# ALERT SERVICE BULLETIN

Service Bulletin No.: DA20-28-02A, Rev. 0

Title: Fuel System Indicating and Storage

Figure 1

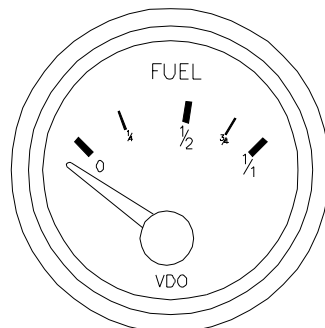
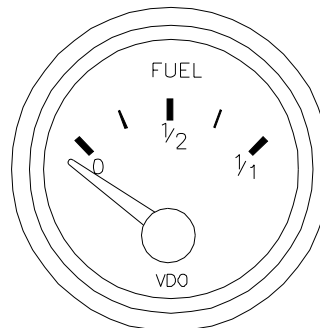
- Part 1** Addresses fuel quantity gauge markings on affected aircraft. A newer design fuel gauge more accurately depicts the volume of fuel in the tank.
- Part 2** Addresses the need for a wiring check and calibration of the fuel quantity indicating system.
- Part 3** Addresses a Fuel Vent modification. A vent line is retrofitted to some tanks, to prevent excessive air entrapment.
- Part 4** Addresses the total fuel tank capacity. The rated capacity is reduced to reflect actual tank capacity. Existing placards are replaced with ones that indicate the revised tank capacity.

**10.1.1** Refer to figure 1 to determine the type of fuel gauge installed on the aircraft.

**10.1.2** If the obsolete gauge is installed contact Diamond Aircraft Customer Support to order a replacement gauge.

**Part 1:** Fuel Quantity Gauge P/N 301-035SB if required.

Figure 2.

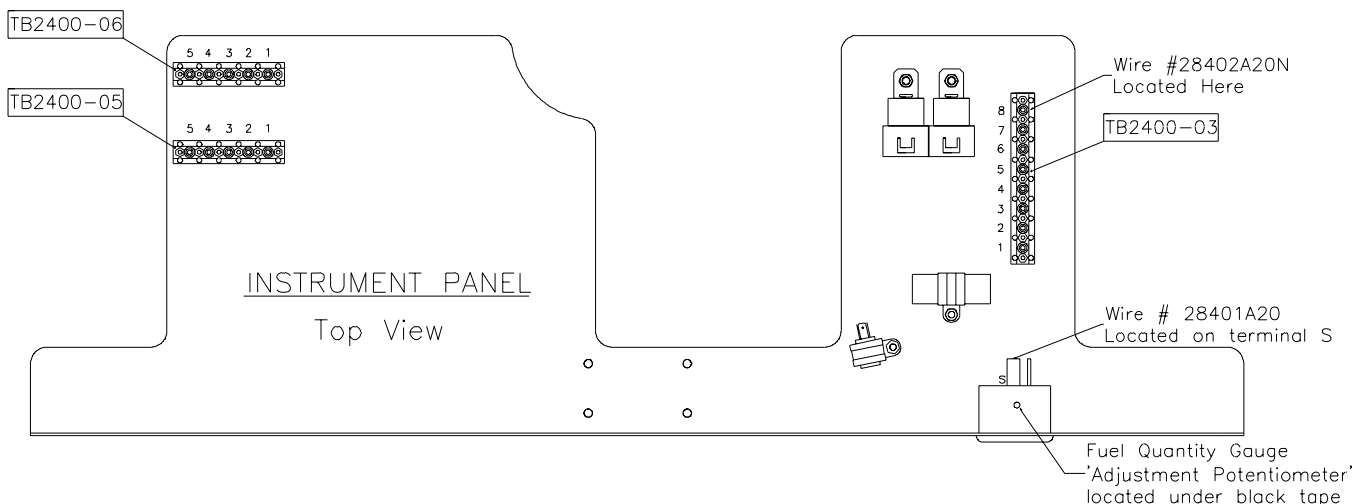
- 10.2.1 Disconnect the battery.
- 10.2.2 Completely drain the fuel tank. Residual fuel is drained via the quick drain.
- 10.2.3 Remove the instrument panel cover.
- 10.2.4 Refer to wiring diagram 20-2400-00-00 sh. 1 & 2.
- 10.2.5 Disconnect J2400-02 from P2400-02 and inspect the connector contacts for cleanliness and condition. Examine the fuel sender signal wire contacts #12 and #13. Clean or replace contacts as necessary.
- 10.2.6 Reconnect J2400-02 and P2400-02.
- 10.2.7 Remove ground wire #28402A20N from Ground Bus TB2400-03 Terminal #8 (Ref. Figure2.).

**10.2.8** Disconnect the signal wire #28401A20 from the fuel quantity gauge. Using a calibrated Ohm Meter, measure the resistance between the fuel signal wire # 28401B20 and the ground wire #28402A20N. See figure 2.

**10.2.9** The resistance measured in 10.2.6 must be between 70-73 ohms. If the resistance is not between 70-73 ohms troubleshoot the wiring and fuel sender to correct the problem.

Figure 3

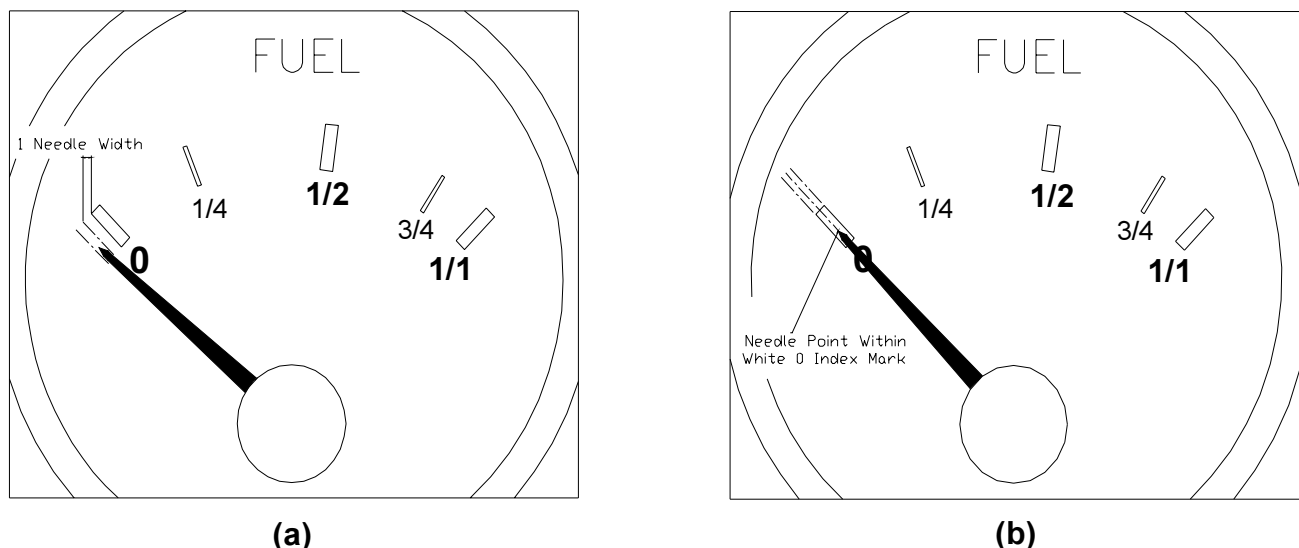
**10.2.14** Adjust the fuel quantity gauge calibration potentiometer, shown in figure 2, so that the needle edge is one needle width below the 0 index mark as shown in figure 3a. Tap the fuel quantity gauge lightly, while adjusting, to remove any friction error.

**10.2.18** Run the engine (or connect a 14 volt power supply to the aircraft electrical system). With the generator on line the needle point must be inside the 0 fuel mark on the fuel quantity gauge as shown in figure 3b. Continue tapping the indicator lightly if necessary.
